Centre Plan Package A | Developer letters and submissions

(February 23 – May 8, 2018)

PROPOSED DESIGN

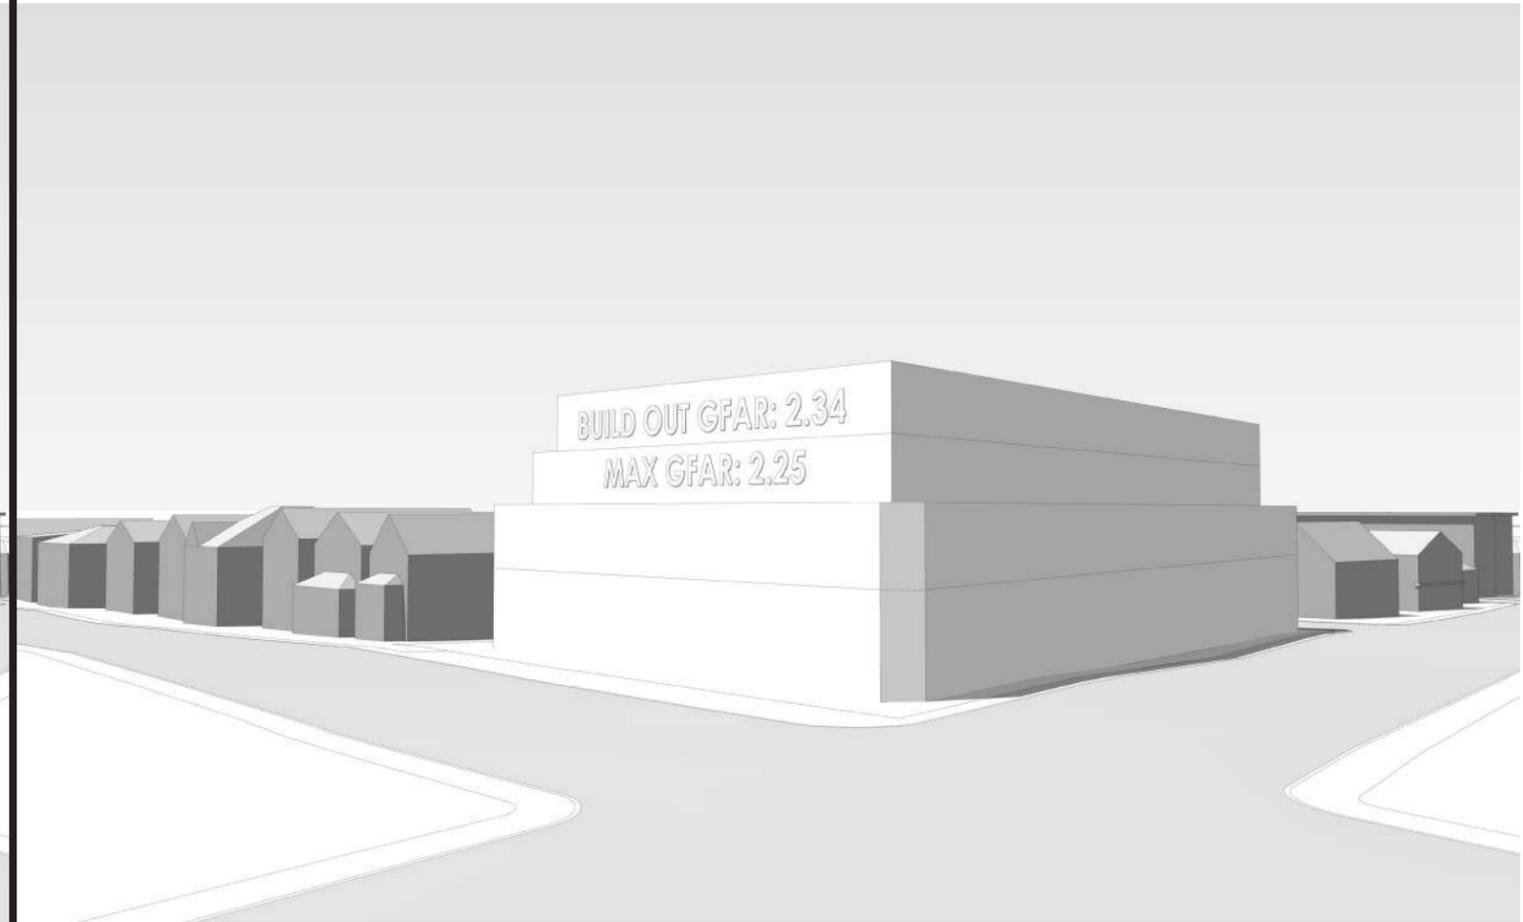
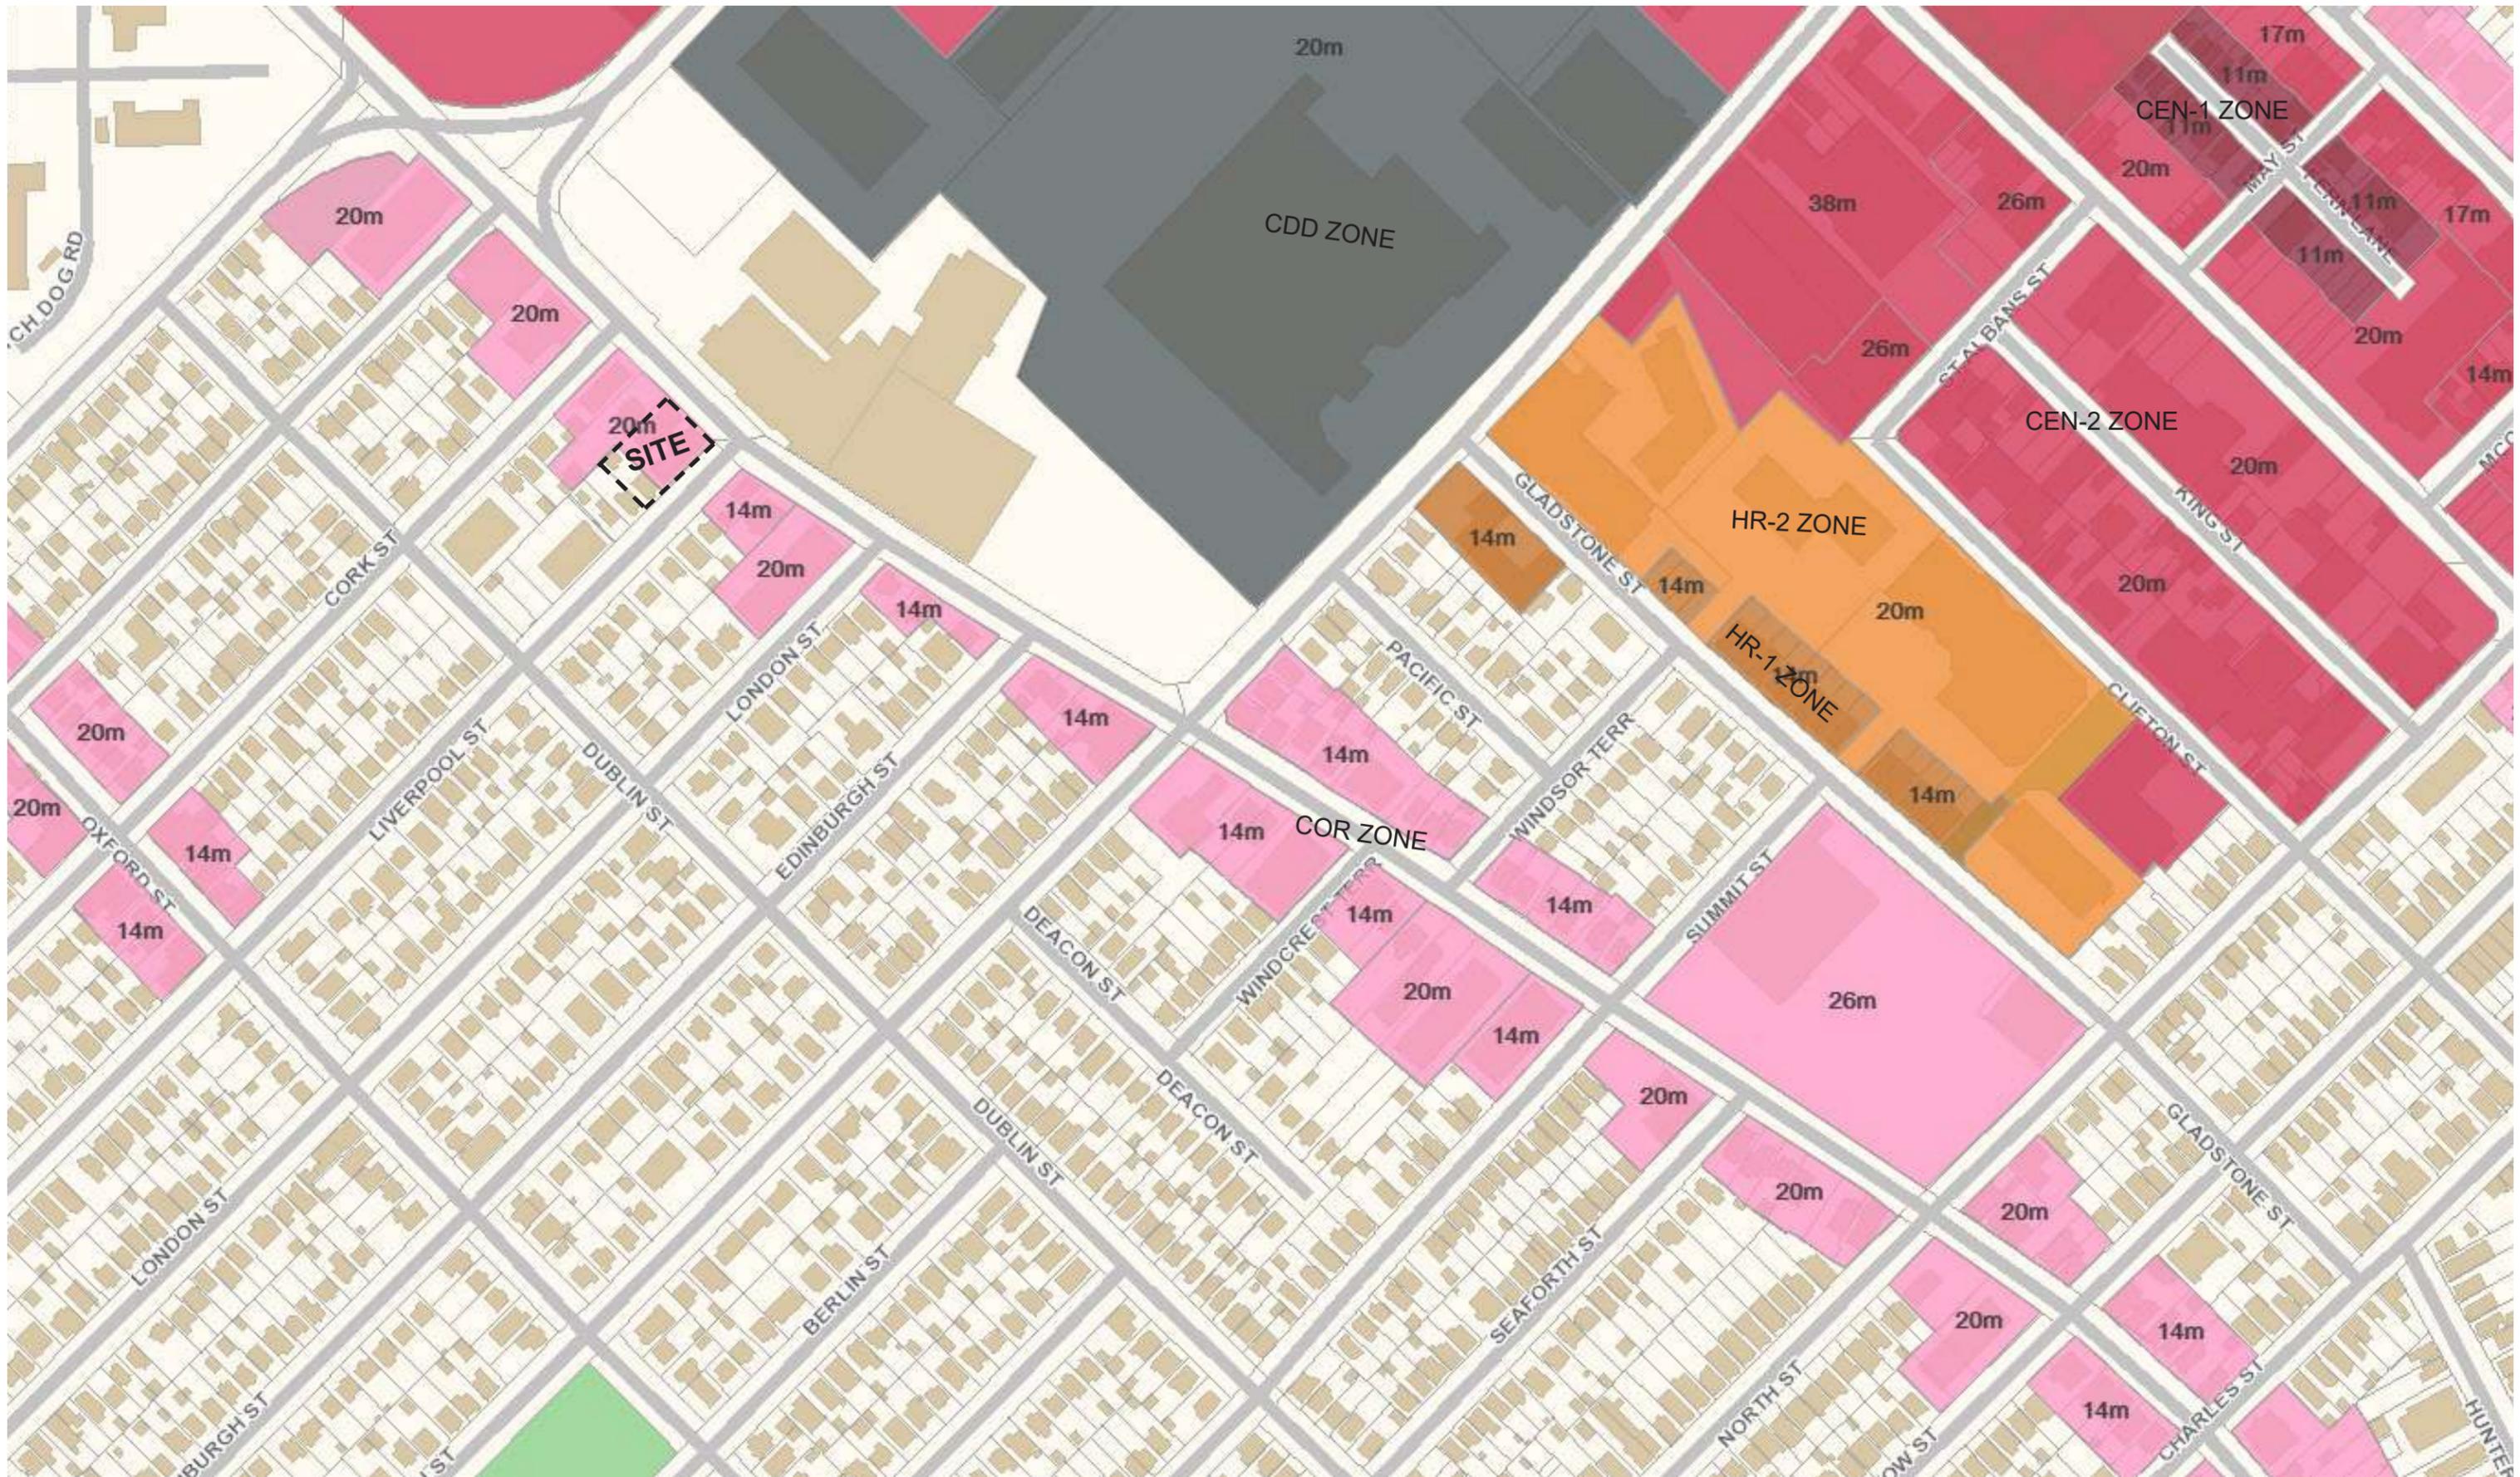
LANDSCAPE REQUIREMENTS	ABUTTING ER DESIGNATION	L2	-	
	STREETYARD	Min. 60%	±90-100%	
	SIDEYARD	N/A	±100%	Unclear in LUB on requirements. Even if setback parameter is 0m, there should be provisions should the design lend itself for a side yard.
	REAR YARD	Min. 50%	±14%	Recommending excluding drive isles and ramps from 50% landscape requirement as most parking entry points will occur at the transitional zone (away from major intersection and aligns with internal building logistics/programing).
VIEWING TRIANGLE		Streetline intersection at 6.0 meters (±20.0 ft)	±3.3 meters (10.7 ft)	Recommending removal of this silly parameter.

PROPOSED DESIGN

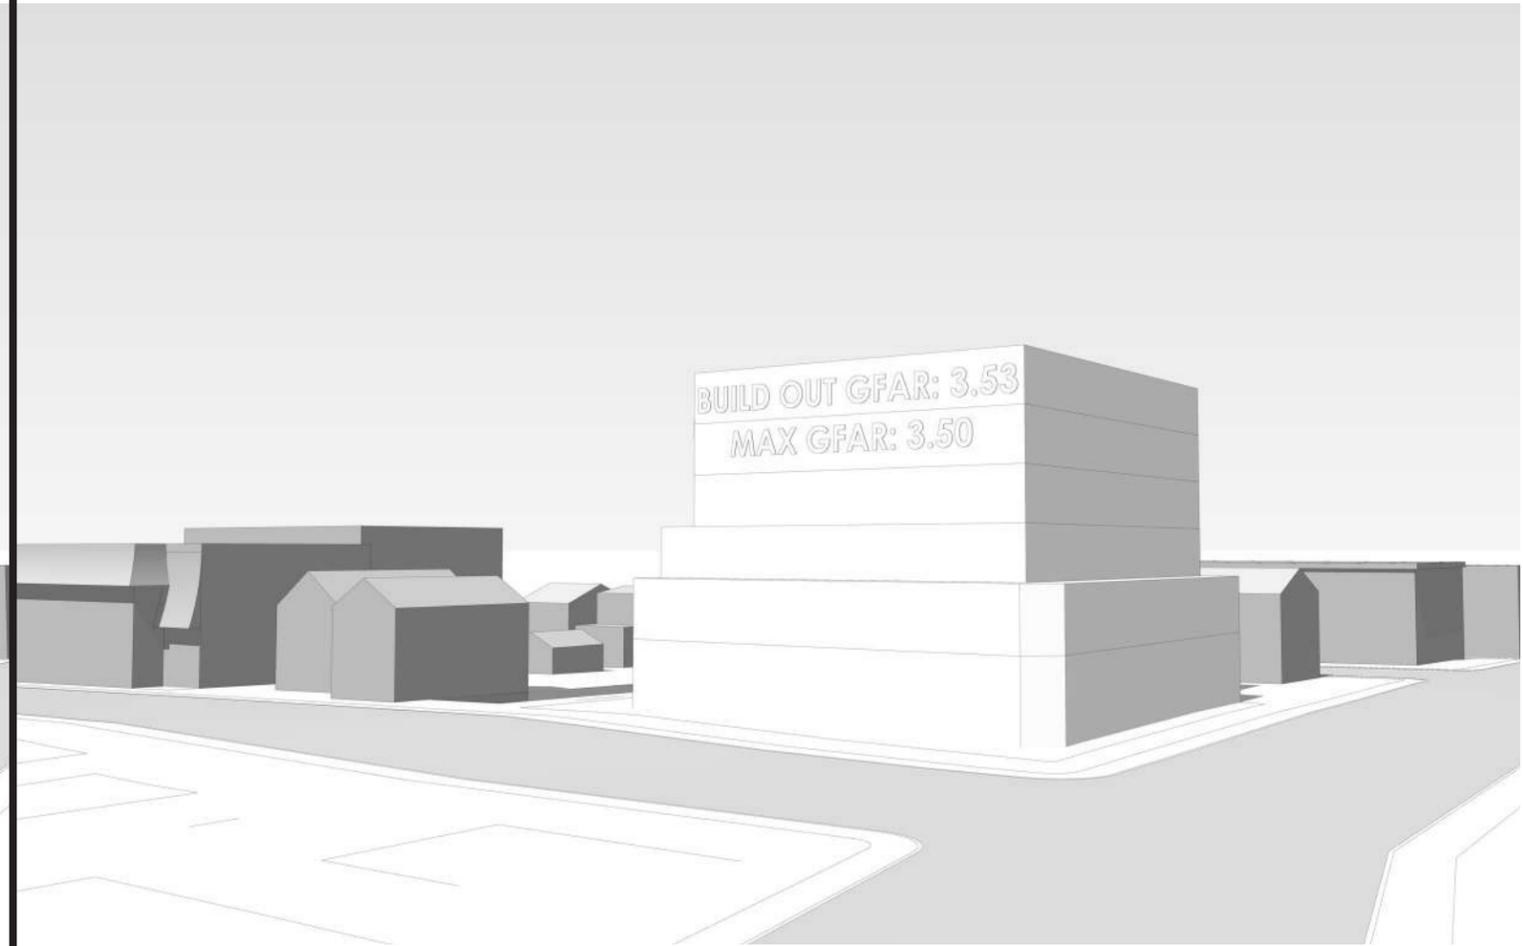
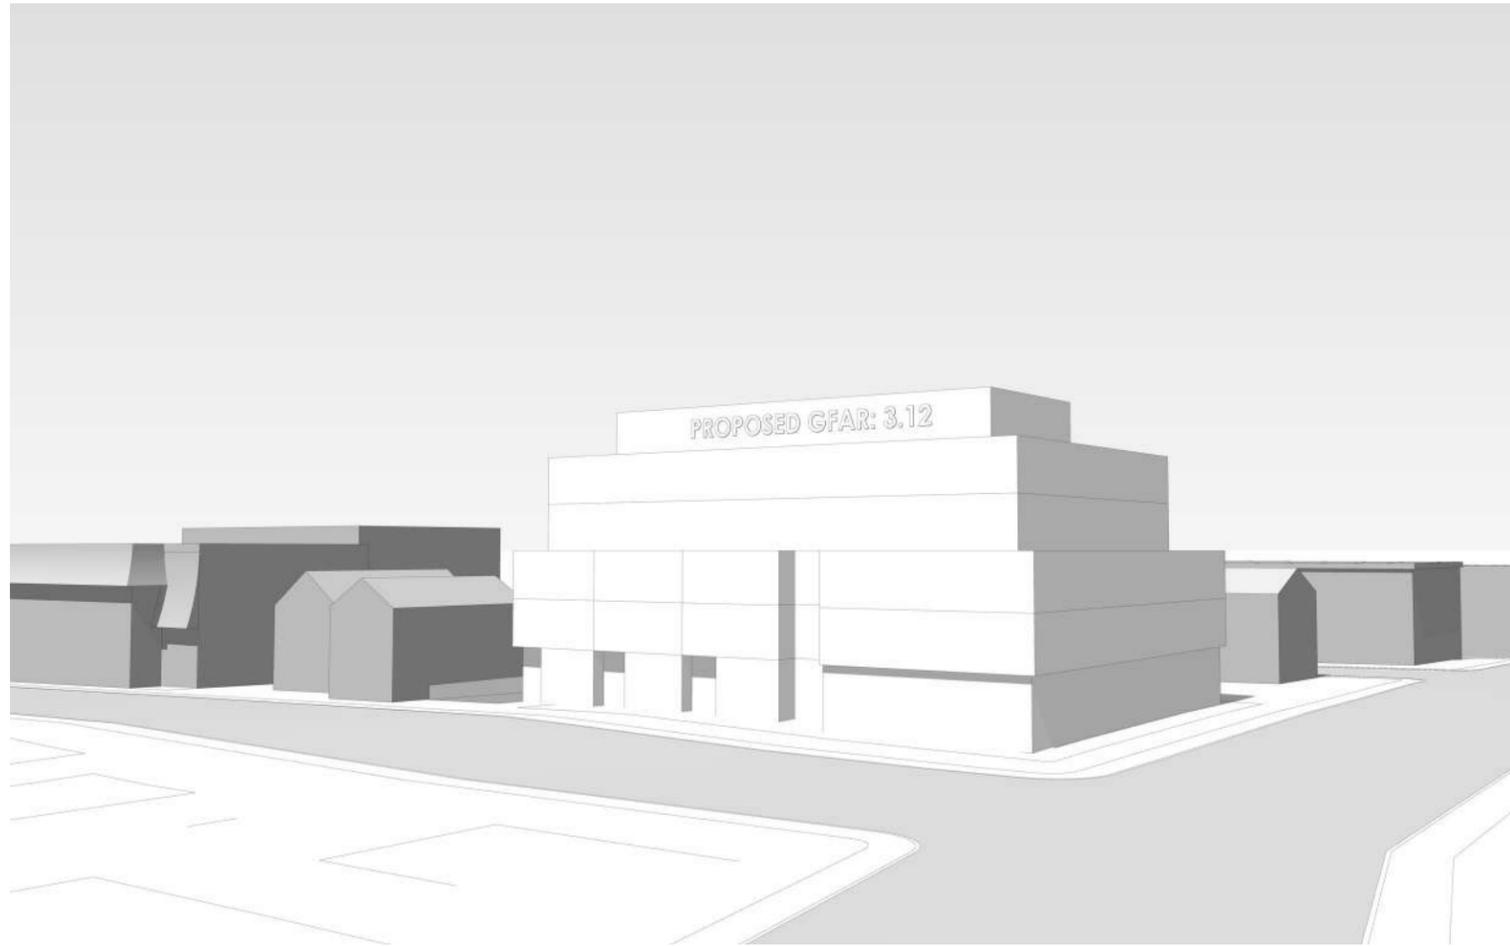
SIDE & REAR STEPBACK	Min. 2.5 m (±8.2 ft)	Side: N/A Rear: ±4.0 m - 5.3 m (± 13.2 ft- 17.4 ft)	Our stepbacks could be reduced to accommodate for larger streetwall stepbacks at 2.5m
LANDSCAPE REQUIREMENTS	ABUTTING ER DESIGNATION	L2	-	
	STREETYARD	Min. 60%	±90-100%	
	SIDEYARD	N/A	±100%	
	REAR YARD	Min. 50%	±86%	
VIEWING TRIANGLE		Streetline intersection at 6.0 meters (±20.0 ft)	±2.3 meters (7.6 ft)	We suggest this parameter to be removed.

PROPOSED DESIGN

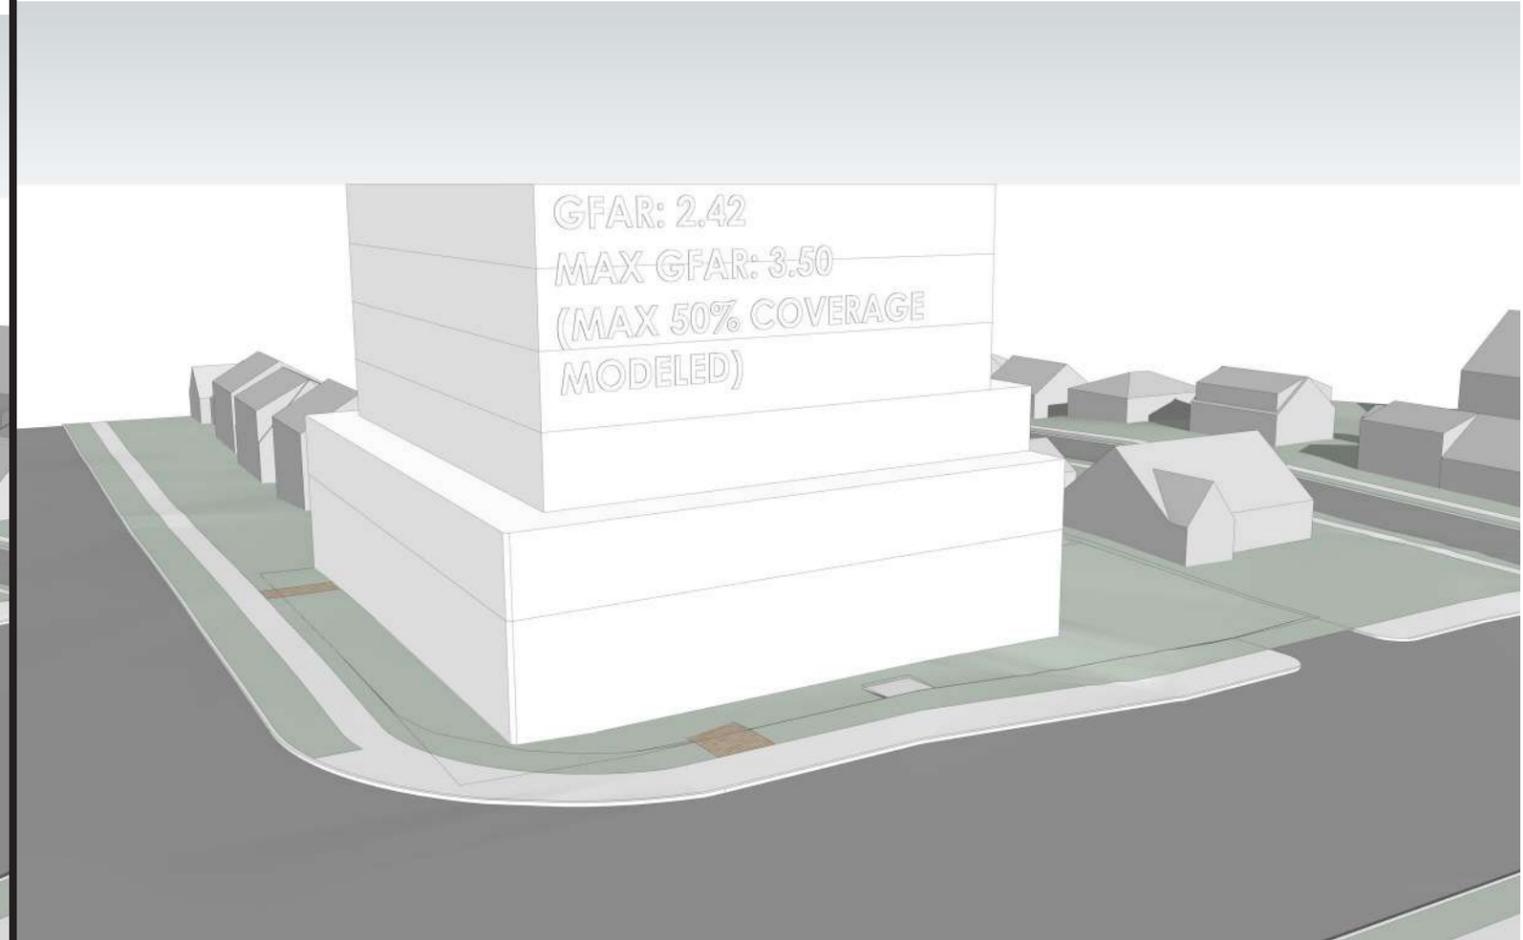
REAR YARD SETBACK		Min. 6.0 m (±20.0 ft)	±4.6 m (±15.0 ft)	We have employed a reduced setback parameter due to site specific conditions of a shallow lot depth and rather large rear yards of adjacent ER-lots. Some flexibility should be permitted for site specific conditions like this.
REAR YARD STEPBACK		Min. 2.5 m (±8.2 ft)	±3.0 m (±10.0 ft)	2.5m is only feasible if streetline setback is relaxed to 0m along Gladstone St. See note above. Our suggested 3m is a product of reduced streetline and rear yard setbacks which we feel is more context sensitive and produces a better built form.
LANDSCAPE REQUIREMENTS	ABUTTING ER DESIGNATION	L1	-	
	STREETYARD	Min. 60%	±90-100%	
	SIDEYARD	N/A	±100%	
	REAR YARD	Min. 50%	±100%	This should be increased to protect visual greenery within transitional areas to ER zones.
VIEWING TRIANGLE		Intersection at 6.0 m (±20.0 ft)	±1.4 m (4.5 ft)	We are strongly suggesting the removal of this parameter all together.

Figure 1 Proposed Centre Plan Zoning and Heights

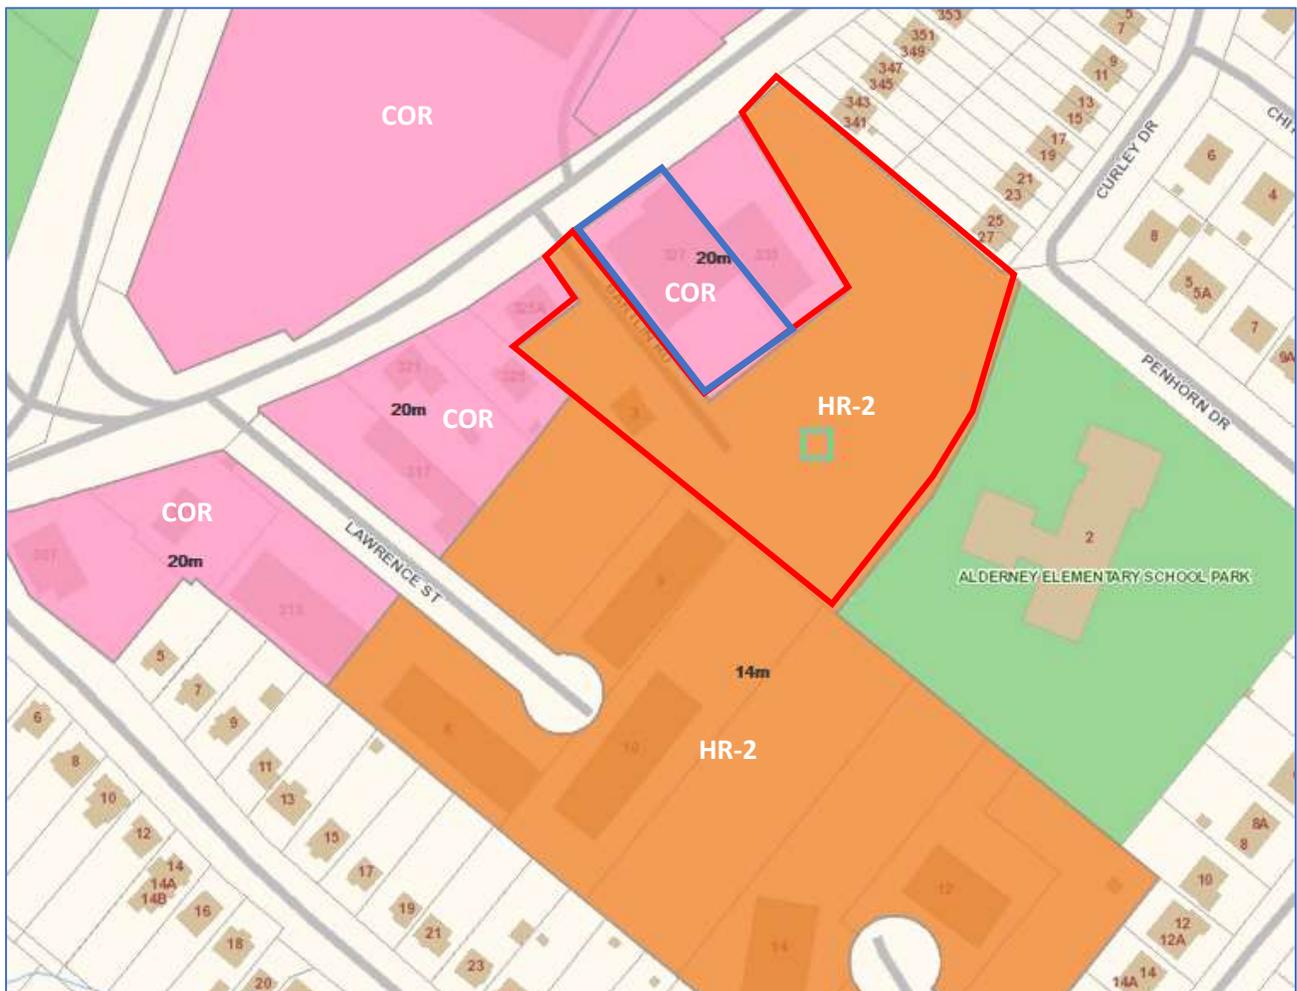
It appears that Centre Plan staff had no awareness as to the existence of a development agreement for a major project on the site. The proposed regulations for 327 Prince Albert are generally acceptable however it is not clear why a combination of built form controls (maximum height, lot coverage, setback
